**FINDINGS AND RECOMMENDATION
OFFICE OF PLANNING AND ZONING
ANNE ARUNDEL COUNTY, MARYLAND**

CASE NUMBER: 2024-0207-V

REQUEST

The applicant is requesting a variance to allow a dwelling addition (porch) with less setbacks than required on property located at 1397 Bayside Drive in Edgewater.

January 29, 2006 - The subject property is the house on the right.

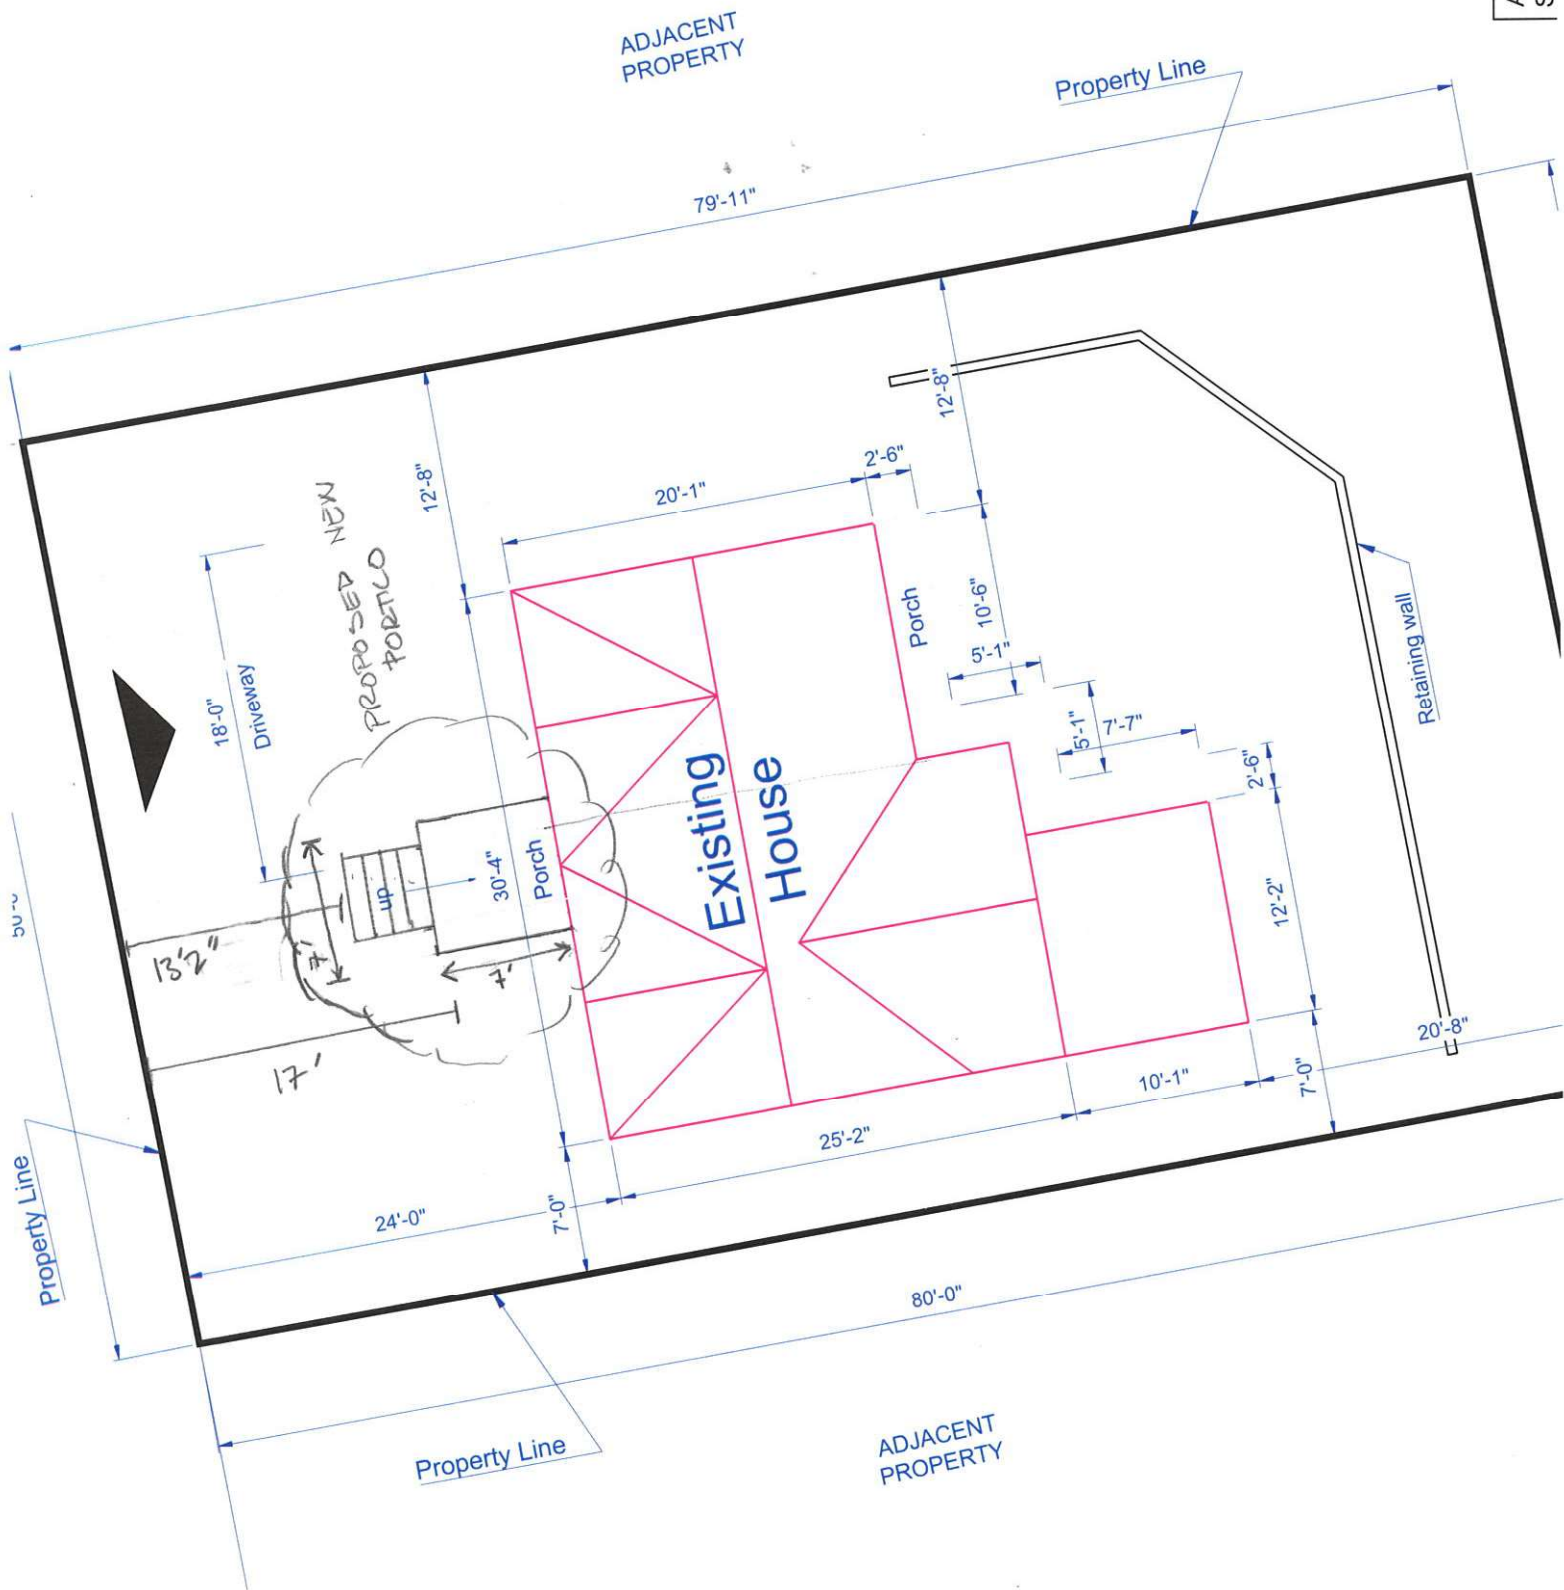
A review of the County 2024 aerial photograph shows a neighborhood in which narrow and undersized lots are the norm. All houses along the east side of Bayside Drive appear to have been constructed with the front facade in-line with each other and appear to be built at the 25' setback line. The dwelling to the east at 1403 Bayside Drive was built in 2006 and did not require a variance. It is in-line with property. Stoops, steps, and decks are common structures on the front of the houses. A few houses have porches or covered stoops. Existing front decks and porches do not appear to meet the front setback requirement. This Office did not conduct a permit history on nearby properties. Through review of aerial photographs of the subject property and the applicant's statement, it appears that the stoop and steps were built at the same time as the dwelling in 2004. The subject property Pictometry image from December 2006 - January 2007 shows the front of the house with the front stoop and steps as described as existing. Note that the other house in this picture is 1403 Bayside Drive. This house has a small covered stoop. §18-2-301(b) allows an architectural feature that does not contain floor area, such as...steps required for access, or stoop that does not exceed five feet by five feet, may extend no more than three feet into a required setback". The stoop at 1403 appears to meet this provision.

The applicant has an existing stoop that is larger than the building code requires, the stoop and stairs appear to have been in place for 20 years and could be replaced in-kind. A porch, in this case, is a convenience. Therefore, the variance requested is unwarranted and cannot be considered the minimum necessary to afford relief.

With regard to the standards by which a variance may be granted as set forth under Article 18-16-305 under the County Code, the Office of Planning and Zoning recommends ***denial*** of the variance request for a front porch with less setbacks than required as shown on the attached site plan.

Address: 139'
Scale: 1" = 10'

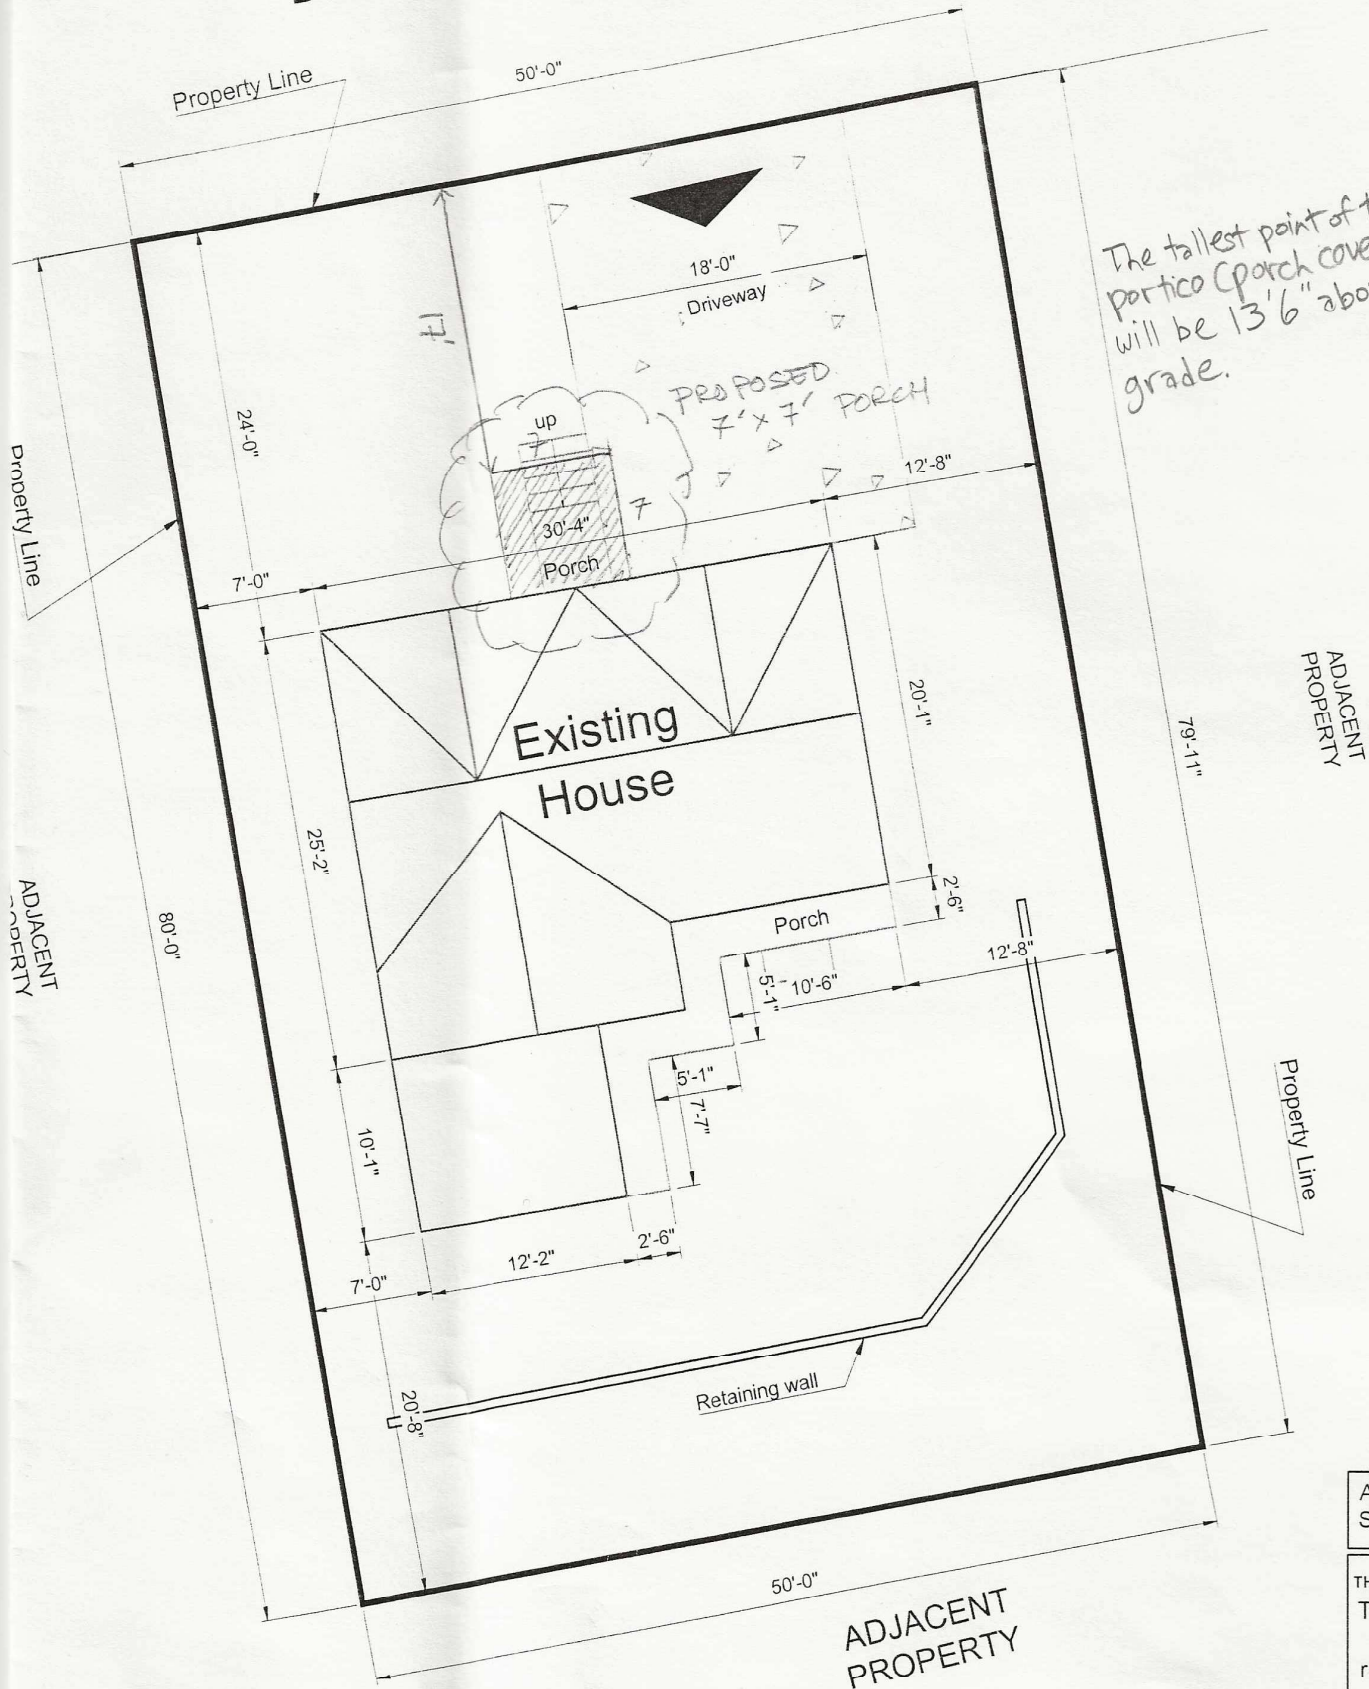
§18-4-701 of the Anne Arundel County Code requires that a principal structure in an R5 District shall be set back a minimum of 25 feet from the front lot line. The proposed porch will be 17 feet from the front lot line and the four steps will be 13' 2" from the front lot line. Variances of 8 feet for the porch and 12 feet for the steps are required.

assessment records the existing dwelling was built in 2004. According to the site plan the existing house does not meet the 25-foot required setback. This Office questions the accuracy of the site plan given that in 2004 the setbacks were the same and there is no variance record on file from 2004. Information in the permit record for the SFD shows that there was a porch 4' x 16' as part of the permit, however, records are not available for construction plans or a site plan.
